# HUSQVARNA TECHNICAL BULLETIN HTB2106

## CHECKING THE MOUNTING POSITION OF THE LICENSE PLATE HOLDER

**2018, 2019, 2020 – VITPILEN 701**

**2019, 2020 – SVARTPILEN 701**

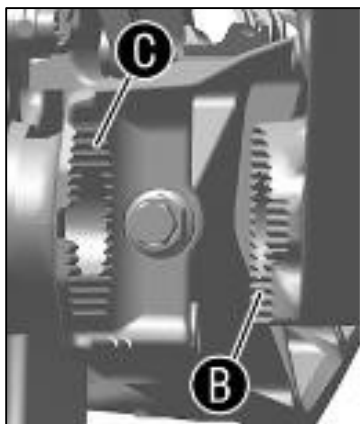
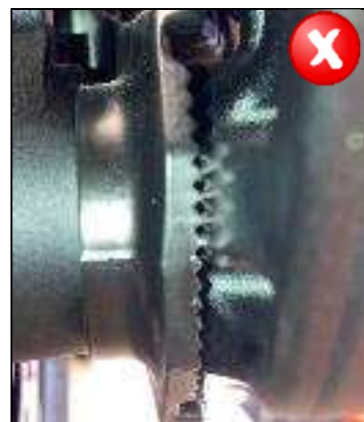
1. Visually check the alignment of the gear teeth on the license plate carrier (B) and swingarm (C). (Fig. 1-3) to verify that they are aligned with each other.
2. If the alignment of the gear teeth on the license plate carrier (B) and swingarm (C) **is correct** as shown in Fig. 2 then retighten rear wheel axle collar nut to 90 Nm to complete the inspection.
3. If the alignment of the gear teeth on the license plate carrier (B) and swingarm (C) **is incorrect** as shown in Fig. 3 then loosen the components and align the gear teeth on the license plate carrier (B) and swingarm (C) correctly.
4. Retighten the rear wheel axle collar nut to 90 Nm to complete the repair.

Component	Screw	Torque	Remark
Collar nut wheel spindle rear	M25x1,5	90 Nm
